TO	Grace McDonald (ESR Australia & New Zealand), NSW Planning Manager	info@asongroup.com.au +61 2 9083 6601 Suite 17.02, Level 17, 1 Castlereagh Street, Sydney, NSW 2000 ABN: 81 168 423 872
FROM	Jae Jeon (Ason Group), Senior Traffic Engineer	
CC	Hamish Boots (ESR Australia & New Zealand), Senior Development Manager	
	Ali Rasouli (Ason Group), Principal Lead	
SUBJECT	3 Johnston Crescent, Horsley Logistics Park (HLP) Stage 2 – Response to Submissions (RtS) Technical Note

Ason Group has been commissioned by ESR Australia & New Zealand to prepare a Transport and Accessibility Impact Assessment (TAIA) to accompany the State Significant Development Application (SSD-71144719) for the proposed warehouse and distribution centre located at 3 Johnston Crescent, Horsley Park and referred to as Horsley Logistics Park (HLP) – Stage 2.

TABLE 1: ASON GROUP RESPONSE TO DPHI COMMENTS

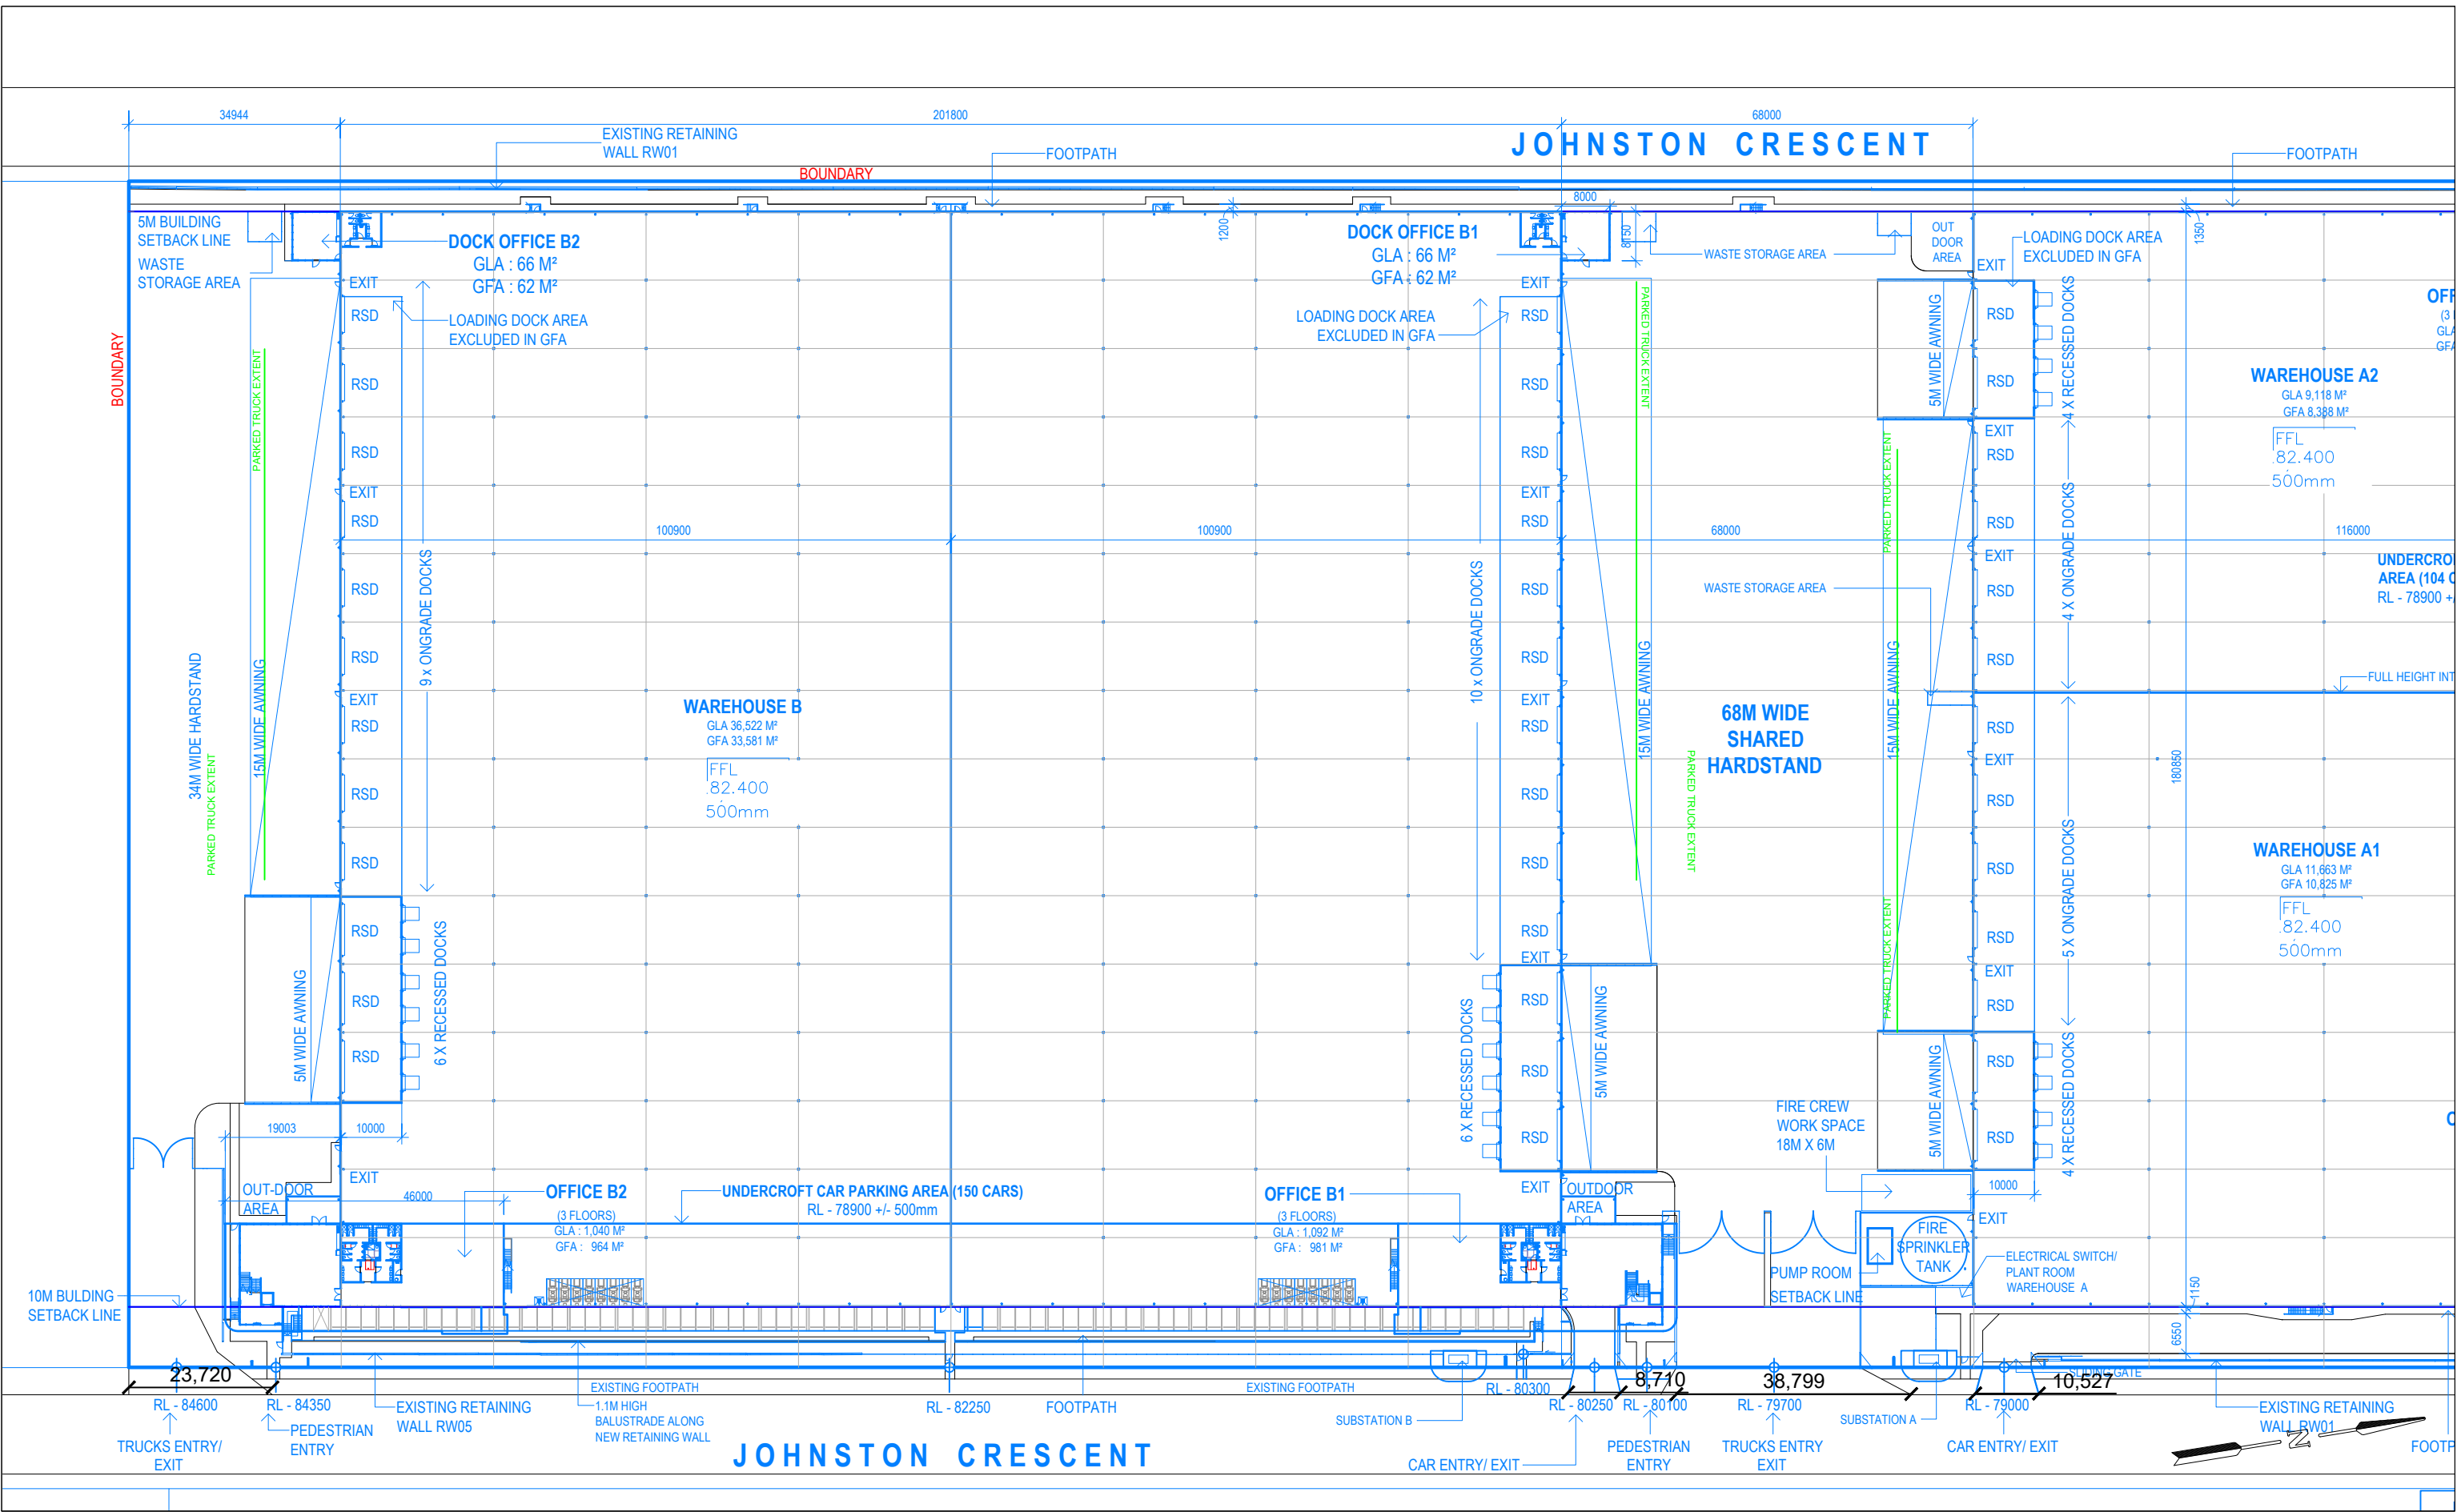
forward direction. The swept path assessment has been provided in Appendix A .
iii. Details of the driveway dimensions are to be provided on the plans.	Appropriate dimensions of the driveway have been provided. The dimensions are provided as part of the swept path assessment and design review in Appendix A .

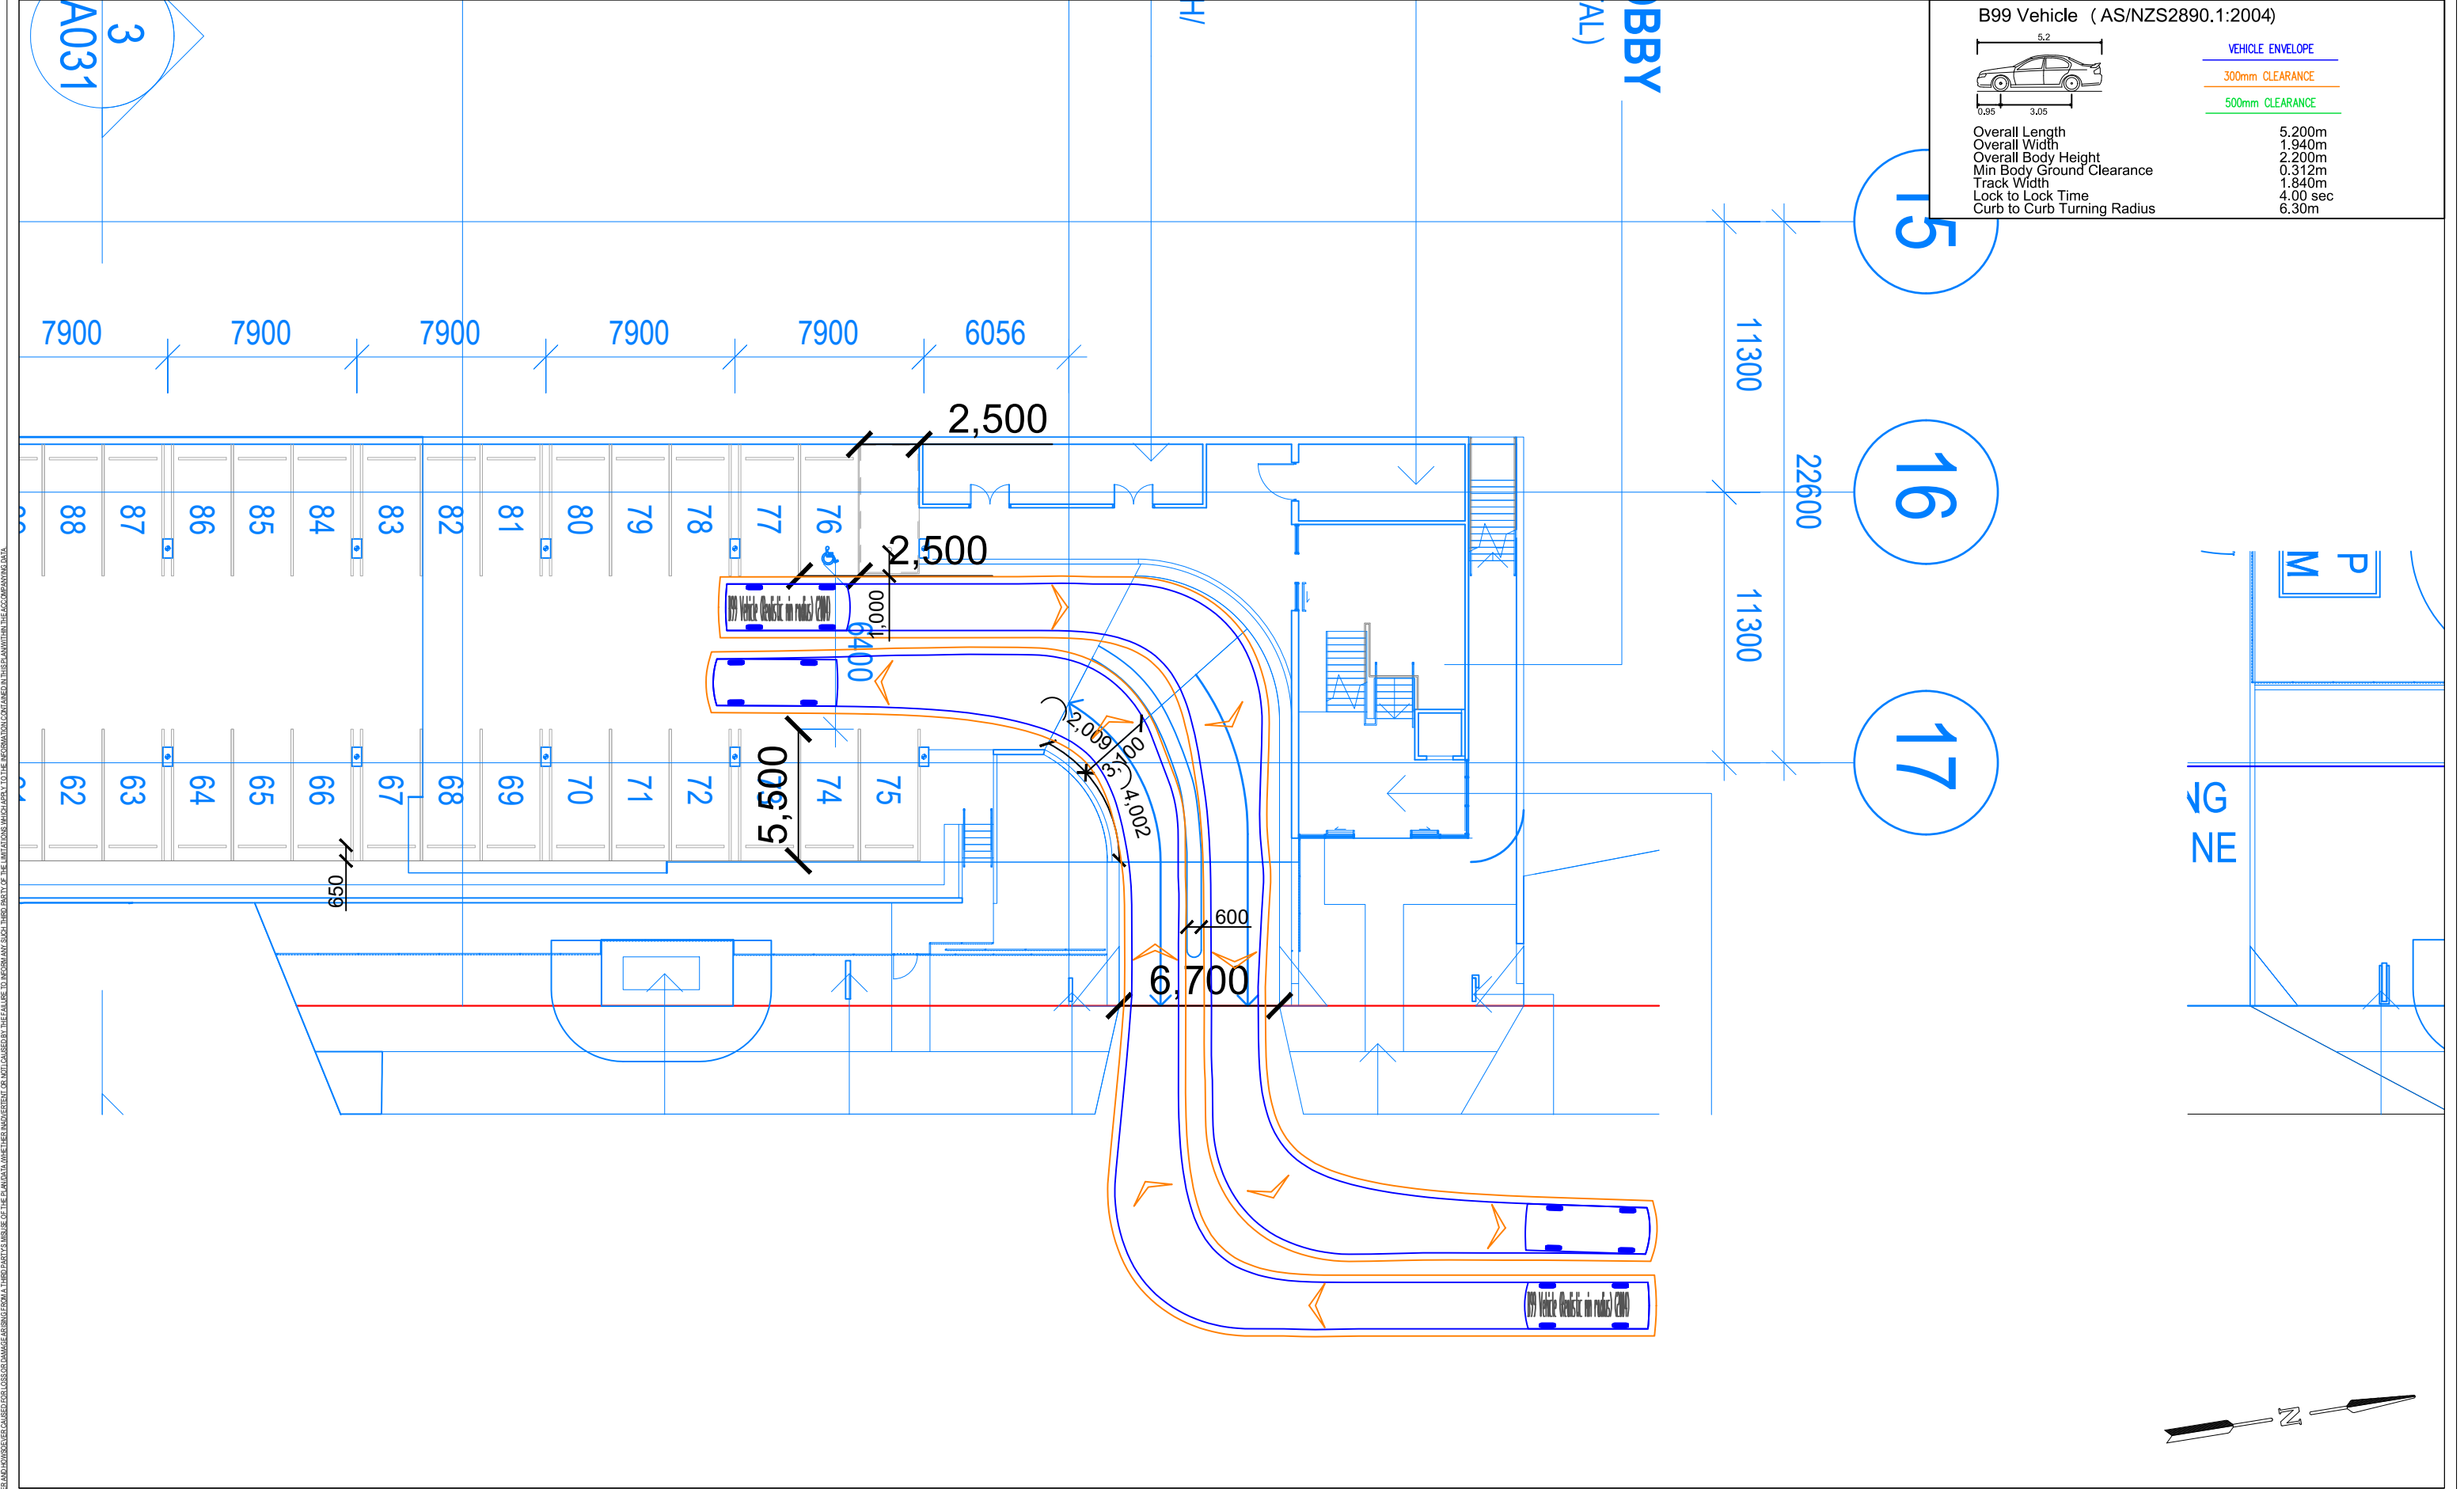
C. Access points and traffic conflicts	-
<p>i. Swept path assessment reflecting the largest vehicle entering and exiting the driveway and circulating within the site including the scenario where all loading docks are occupied, and a truck needs to turn around and exit the site shall be provided to ensure potential conflicts in traffic movements have been considered.</p>	<p>It is noted that an Operational Traffic Management Plan will be prepared to ensure that such situations are avoided whereby a vehicle enters the Site when no loading docks are available. However, in the rare occasion due to unforeseen circumstances that such situation occurs, the Site provisions for ample hardstand areas where a vehicle can temporarily wait whilst a bay becomes available within the Site and not impact on the external road network.</p> <p>Swept path assessment has been prepared using a 26.0m B-Double which is expected to be the largest vehicle entering and exiting the Site. The assessment indicates that the proposed access driveway design can accommodate the manoeuvres therefore is considered appropriate. The swept path assessment has been provided in Appendix A.</p>
